**ZONING AMENDMENT,
PLANNED UNIT DEVELOPMENT &
SUBDIVISION STAFF REPORT**

<u>NAME</u>	La Belle LLC.
<u>SUBDIVISION NAME</u>	La Belle Subdivision, Re-subdivision and Addition to Lot 1
<u>LOCATION</u>	5951 & 5955 Old Shell Road and 14 East Drive (Southwest corner of Old Shell Road and East Drive)
<u>CITY COUNCIL DISTRICT</u>	District 6
<u>PRESENT ZONING</u>	R-1, Single-Family Residential District, and B-2, Neighborhood Business District
<u>PROPOSED ZONING</u>	B-2, Neighborhood Business District
<u>REASON FOR REZONING</u>	Subdivision of land, and resolution of a split-zoning issue created by the proposed Subdivision.
<u>AREA OF PROPERTY</u>	1 Lots / 1.3 ± Acres
<u>CONTEMPLATED USE</u>	<p>Subdivision approval to create 1 lot, Planned Unit Development Approval to amend a previously approved Planned Unit Development to allow multiple buildings on a single building site, and Rezoning from R-1, Single-Family Residential District, and B-2, Neighborhood Business District, to B-2, Neighborhood Business District to eliminate split zoning in a proposed Subdivision and allow construction of a parking lot.</p> <p>It should be noted, however, that any use permitted in the proposed district would

SITE PLAN

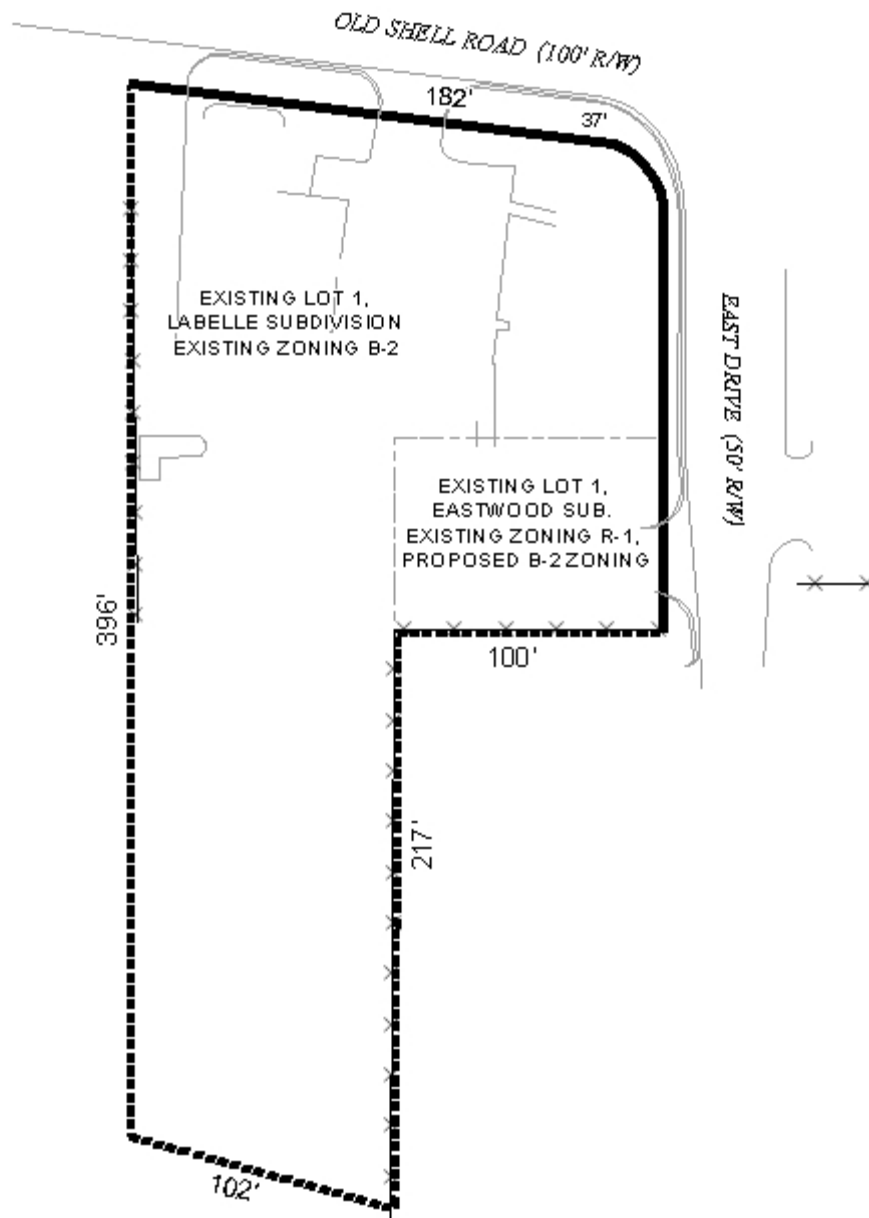
Driveway number, size, location, and design to be approved by Traffic Engineering and conform to AASHTO standards. The proposed concrete driveway on East Drive is skewed at an approximate 60° angle. Exiting traffic is aimed away from Old Shell Road; vehicles not likely to exit at this angle will block southbound vehicles from entering the driveway. Driveway should be designed with minimum skew; 90° angle is desired. A 20' radius is typical for passenger cars and a 30' radius is desirable for large trucks. The distance between the edge of pavement and right-of-way line (approximately 10') and the proximity of live oak trees may prohibit the proper radius; if so largest possible radii are desired.

The revised site plan depicts a realigned entranced onto East Drive, to address Traffic Engineering concerns, new 3-foot high vegetative buffering where the site abuts existing single-family residences, a fenced in dumpster area, and new trees for tree compliance: it should be noted that three of the required frontage trees are located outside of the frontage area due to site constraints, according to the applicant. Frontage area for new tree planting, especially live oaks, is constrained, thus relocation of frontage trees to other areas of the site, as proposed, is a reasonable request.

The vegetative buffering and greenspace between the new parking area and the abutting residence will only be 5-feet in width, which is less than that required for that portion of the existing parking lot extending behind the residences. Staff recommends that this greenspace area be expanded to 15-feet in width (to match a previous Zoning buffer requirement), eliminating six (6) proposed parking spaces. Staff also recommends that all proposed vegetative buffering be evergreen, and six (6) feet high at the time of planting, in addition to 6-foot high privacy fencing. As the site also abuts residentially-zoned properties to the South and West, a 6-foot high privacy fence or 10-foot wide vegetative buffer with 6-foot high evergreen hedge should be provided.

As a new curb-cut is proposed onto East Drive, staff recommends that the existing one-lane wide driveway on the West side of site be eliminated. The paving should be removed along the entire length abutting the Picklefish restaurant, the area landscaped, and curbing added to prevent access from Old Shell Road or from the existing parking lot.

Access to the new parking area from the existing parking area will be via a 24-foot wide driveway that will extend between two existing parking spaces. As no curbing or radius is provided for the driveway, cars parked in the existing parking spaces will likely be at high risk for damage by other vehicles, including delivery trucks, which will inevitably choose to enter or exit via the East Drive curb-cut. Staff recommends that the two abutting parking spaces be eliminated and replaced with curbed planting islands.

A sidewalk along East Drive is not depicted where the new parking area is proposed. As the site is commercial, a sidewalk waiver request must be submitted to the Planning Commission for consideration, or a sidewalk must be provided.

The existing dumpsters do not meet the 10-foot setback requirement for commercial sites abutting residentially zoned properties. While an appropriate dumpster enclosure is proposed, there appears to be sufficient room to relocate the dumpsters and the proposed enclosure to meet all setback requirements.

Driveway number, size, location, and design to be approved by Traffic Engineering and conform to AASHTO standards. Driveway has been modified to minimize skew at roadway. Centerline striping between East Drive and parking spaced to the west is highly recommended to delineate travel lanes for entry and exit.

- 1) All site lighting to comply with Sections 64-4.A.2. and 64-6.A.3.c. of the Zoning Ordinance, and the applicant must submit documentation regarding lighting compliance, including the physical location of new lighting on the property and a photometric plan of the lighting;*
- 2) Provision of a 15-foot wide greenspace area, with 6-foot high (at time of planting) evergreen vegetative buffer and 6-foot high wooden privacy fence, where the site abuts single-family residences fronting East Drive, revising the site plan to eliminate 6 proposed parking spaces;*
- 3) Provision of a protection buffer in compliance with Section 64-4.D.1. of the Zoning Ordinance along the Southern and Western boundaries of the site, where it abuts residentially zoned properties;*

- 4) *Removal of the western-most driveway access to Old Shell Road, with curbing and landscaping to prohibit use of the driveway area, and removal of all paving abutting the Picklefish restaurant on the western side;*

- 5) *Elimination of two parking spaces adjacent to the proposed 24-foot driveway linking the existing parking area to the new parking area, and replacing the parking spaces with curbed landscaped islands;*

- 7) *Revision of the site plan to depict the relocation of the existing dumpsters and the proposed enclosure to meet a minimum 10-foot setback from any property line where the site abuts residentially zoned property;*
